Response to NRC Review Questions

LaCrosse Boiling Water Reactor
Dairyland Power Cooperative
Genoa, Wisconsin 54632

Re: Response to NRC Review Questions

We are submitting ten copies of the report "Response to NRC Review Questions, Seismic Hazard and Liquefaction Potential at LACBWR Site, near Genoa, Vernon County, Wisconsin" for your use. This report contains answers to all the questions raised by the Nuclear Regulatory Commission (NRC) in their letter of April 25, 1980, to Dairyland Power Cooperative (DPC).

LACBWR PILING PLAN

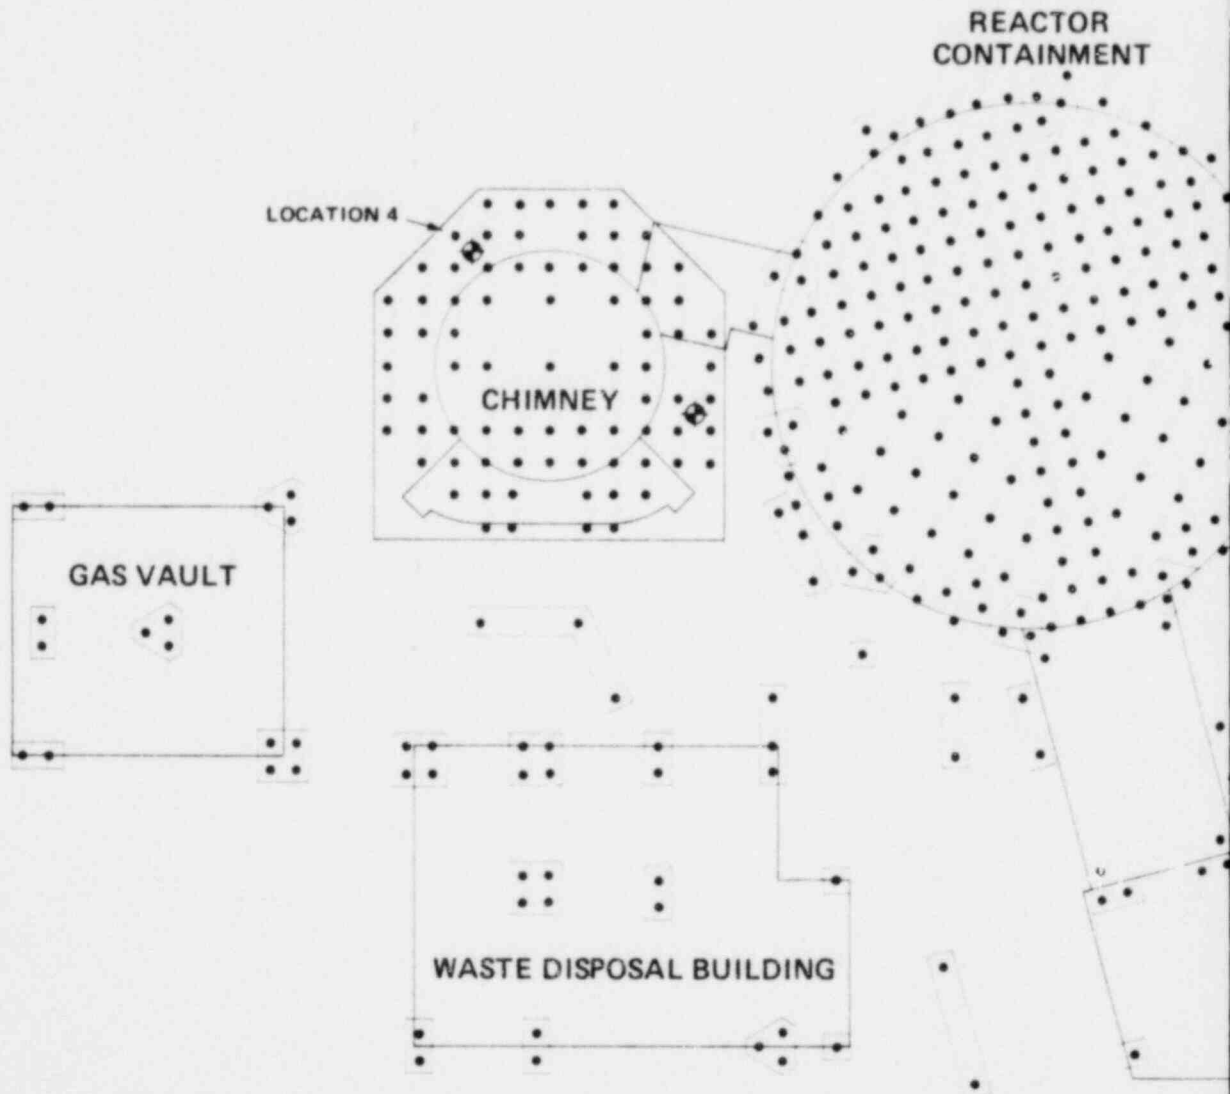
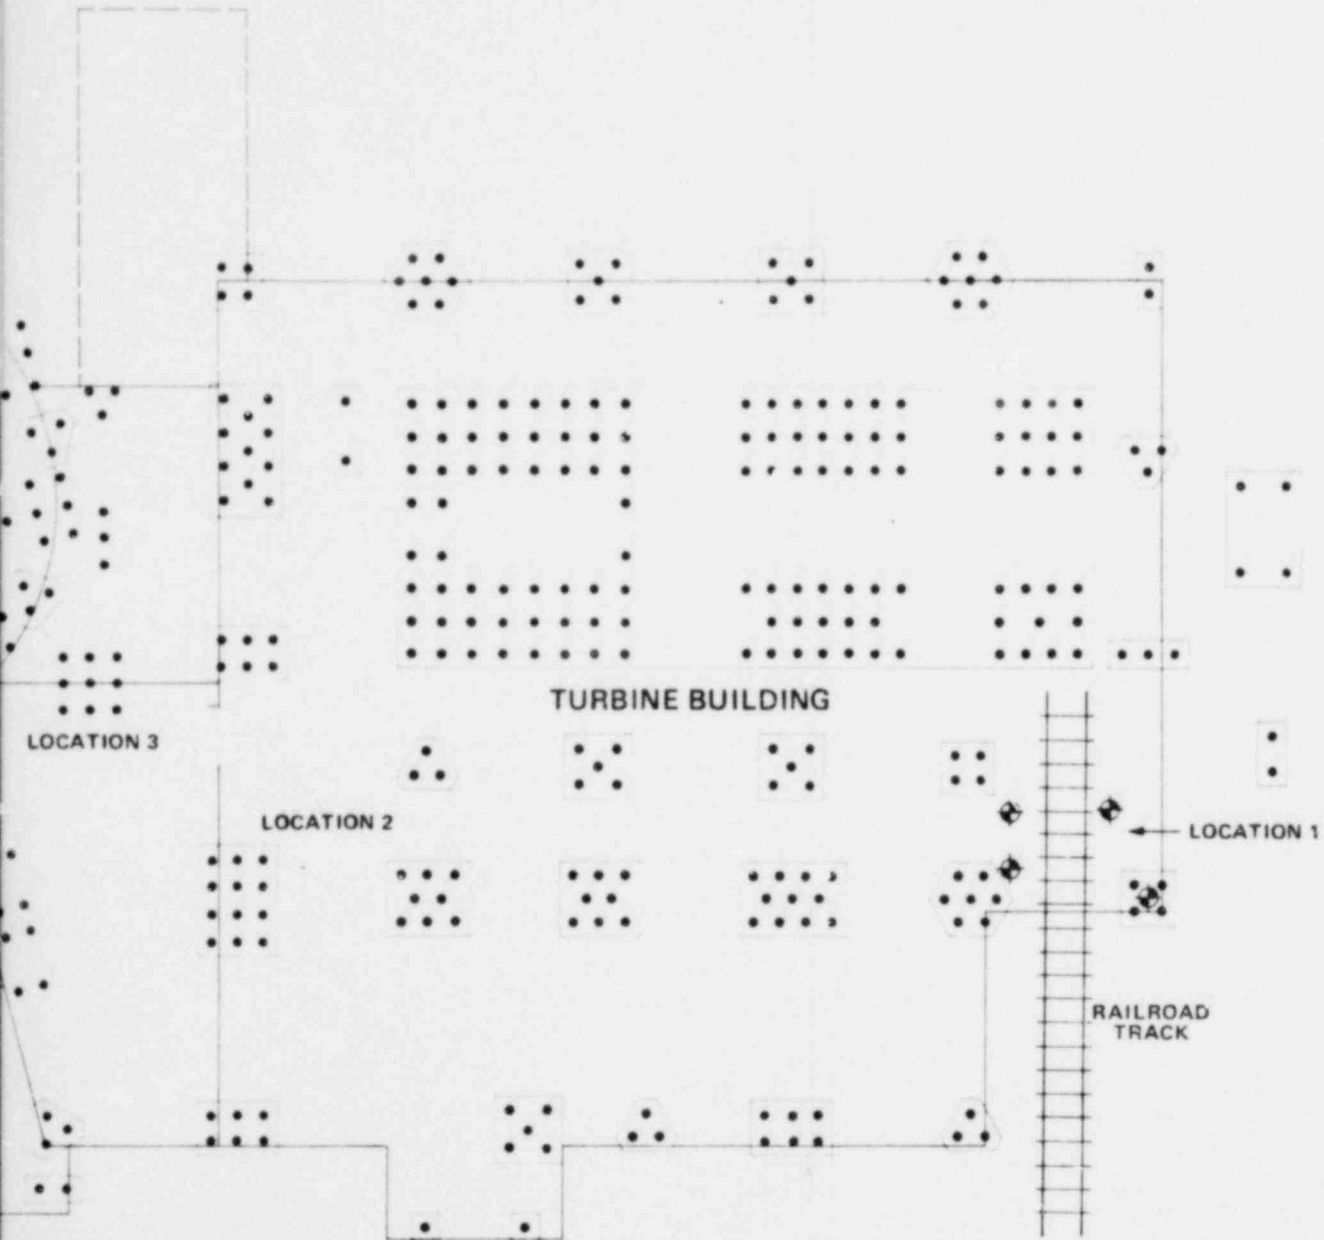
Question 2d

All the potential areas where access to a drill rig could be provided for substantiation of N values under existing structures were examined and five locations were identified (see figure 2d-2-1). Location 1 is a relatively open area within the turbine building with sufficient head room and easy access for a drill rig. (Even a truck mounted rig could be used at this location.) A 4-foot thick concrete floor would have to be penetrated before SPT's could be performed at Location 1.

Location 2 is a relatively small free area in the turbine building with difficult access conditions and some restrictions to working. A very light skid rig with small overall dimensions (such as the Acker-Ace with approximate dimensions of 3½-feet x 6 feet and approximate weight of a ton, with a motor and a 15-foot boom that can be easily separated from the rig) can be hoisted from Location 1 and moved parallel to the roof and brought down through the hatch at Location 2. Certain light equipment in the area will require shifting during the drilling period. As in Location 1, penetrating through the concrete floor is necessary before SPT's can be performed.

Location 3 in the turbine building is the most difficult drilling location with restrictions on head room (about 14 feet), lack of flexibility in the drill hole location, and the need to go through a high-radiation area. The drill hole location is inflexible because of tightly spaced equipment in the tunnel through which the hole has to advance. An 8-inch diameter hole in the floor of the machine shop (Location 3) provides access in between the various pieces of equipment in the

Two other locations, Locations 4 and 5, were identified outside the buildings. Location 4 is on the pile cap of the stack where easy access for a small drill rig will be available. After about 4 feet of reinforced concrete pile cap has been cored through, SPT's can be performed within the pile cluster under the stack. The piles under the stack are at slightly greater spacings than the piles under the containment. Data from SPT's performed here may provide information which may indirectly substantiate the assumed conditions within pile groups at similar depths.

Location 5 is a free area outside all structures where a small-scale pile-driving program may be undertaken. With SPT values obtained before and after the

Figure 5-1 Boring DM-1 (1973)

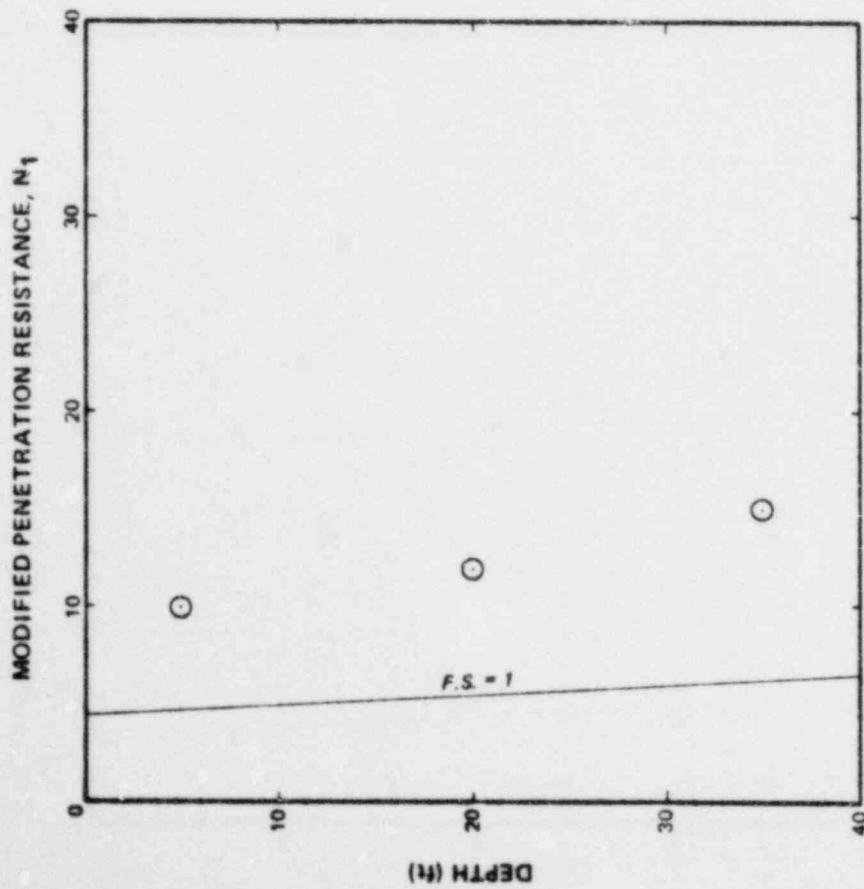
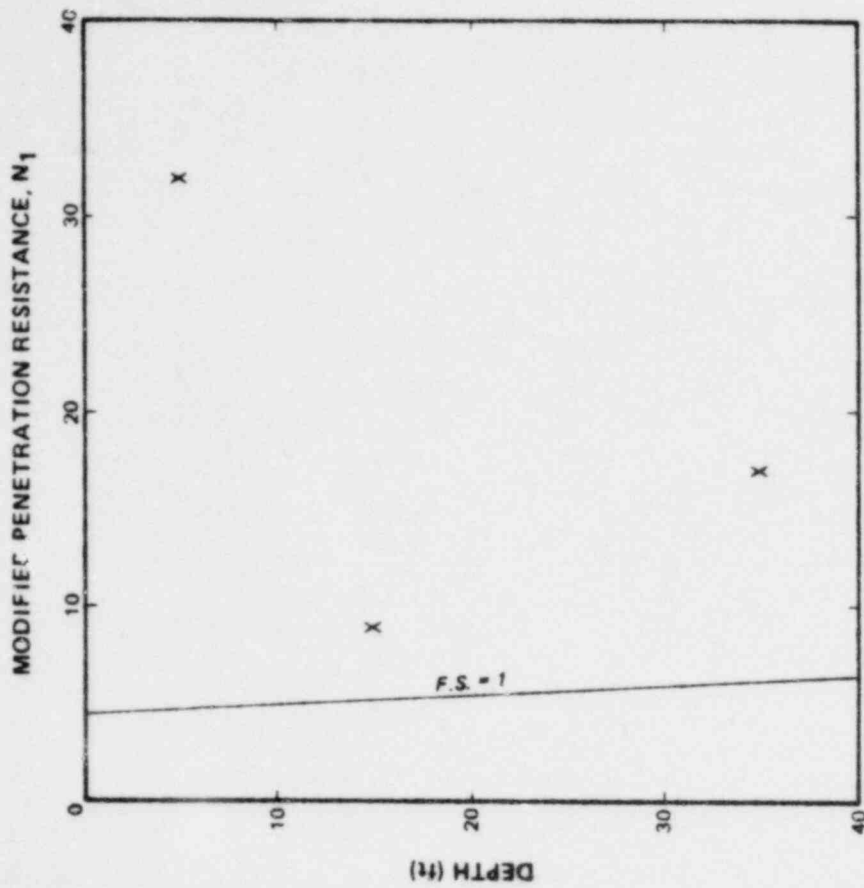
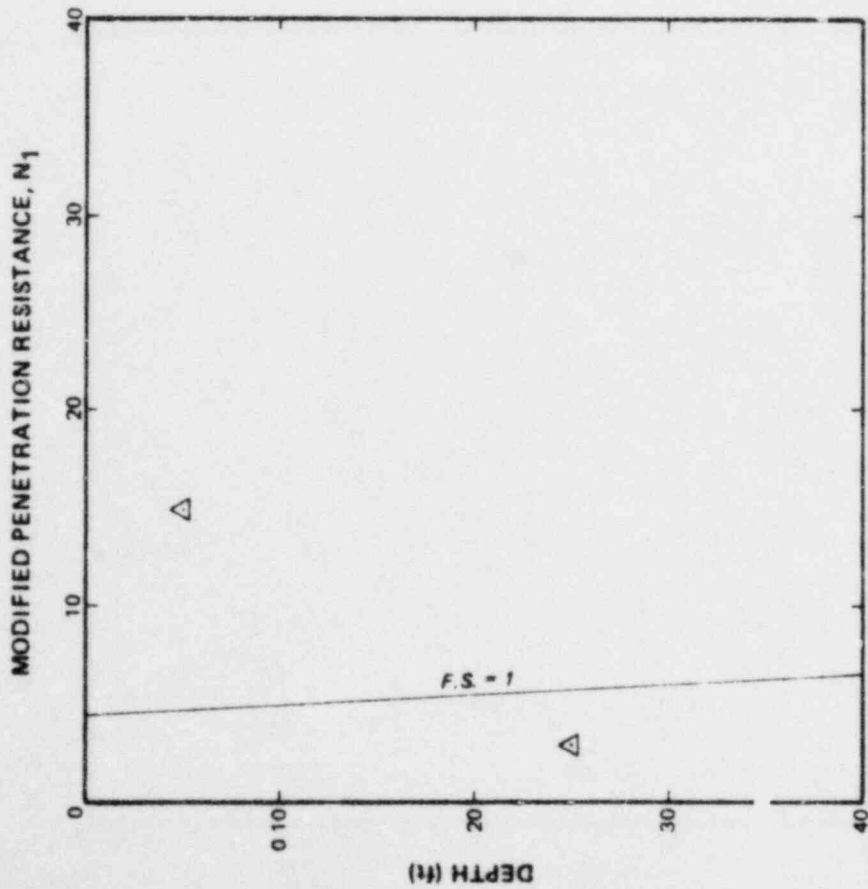
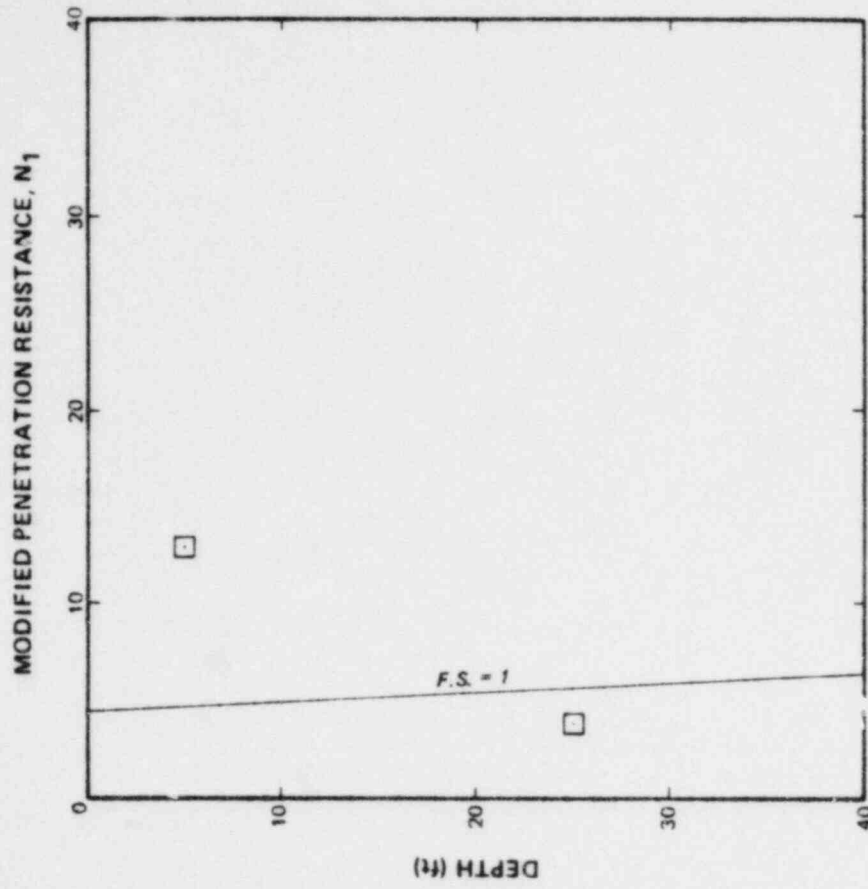
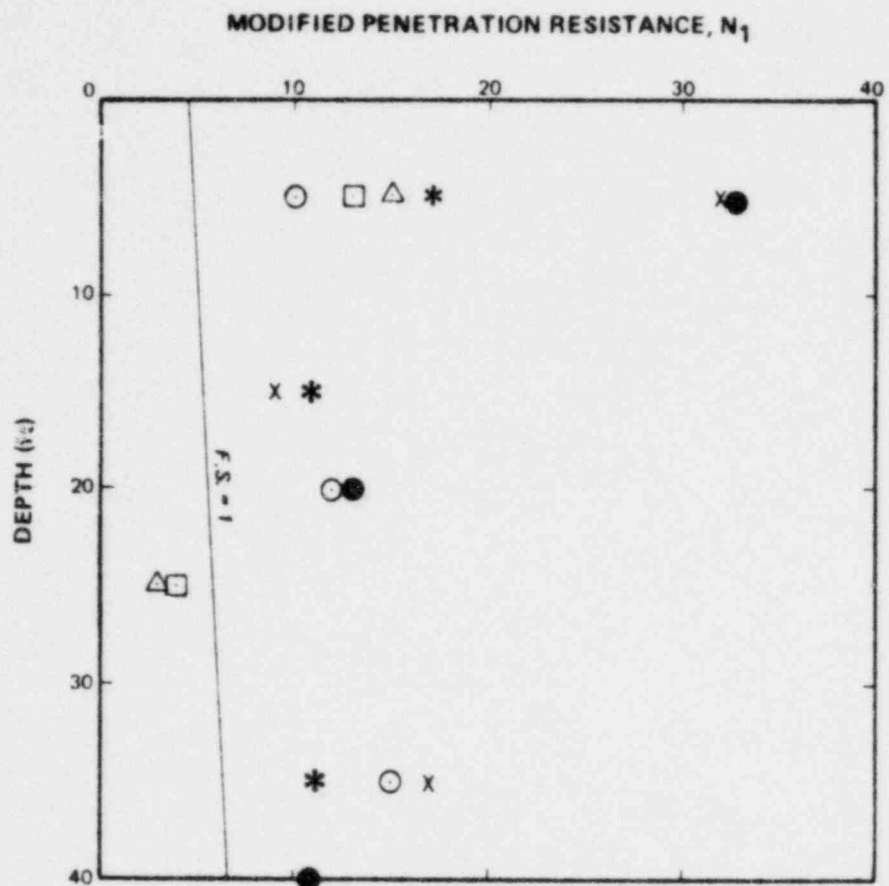
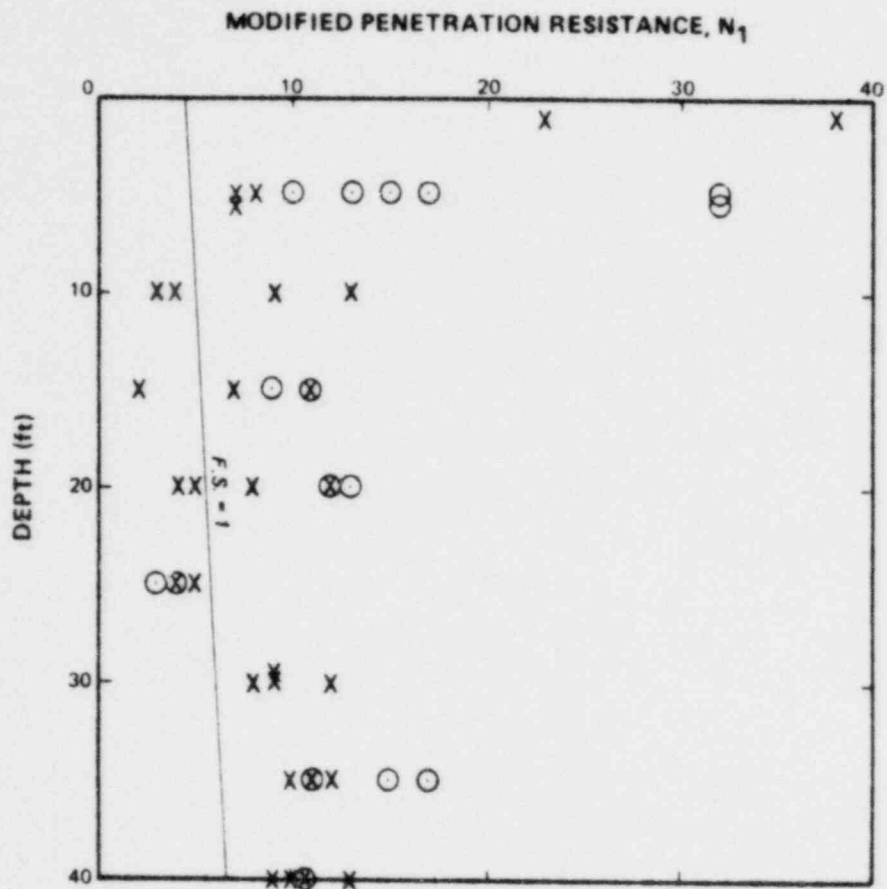
5. Provide a tabulation of all N_1 and depth values for each boring and plot the results on a figure with N_1 as the abscissa, and depth as the ordinate. Show the location of the FS=1.0 line.

Also shown on each plot is a line indicating N_1 values for which the factor of safety equals 1.0 for a given depth. To determine the N_1 values for this line, average cyclic shear stresses from a one-dimensional wave propagation analysis for 0.12-g surface acceleration (from table 6 in the D&M report of September 28, 1979, reference I-4) were compared to effective overburden pressure to yield a cyclic shear stress ratio for each depth. The stress ratios were then related to the line indicating the upper bound for liquefaction potential for the given acceleration, as shown in figure 7 of reference I-4. The corresponding N_1 values were plotted as the line designated (F.S. = 1) in the plots attached here.

These N_1 values represent free-field conditions, relatively unaffected by the densification effect of pile driving.
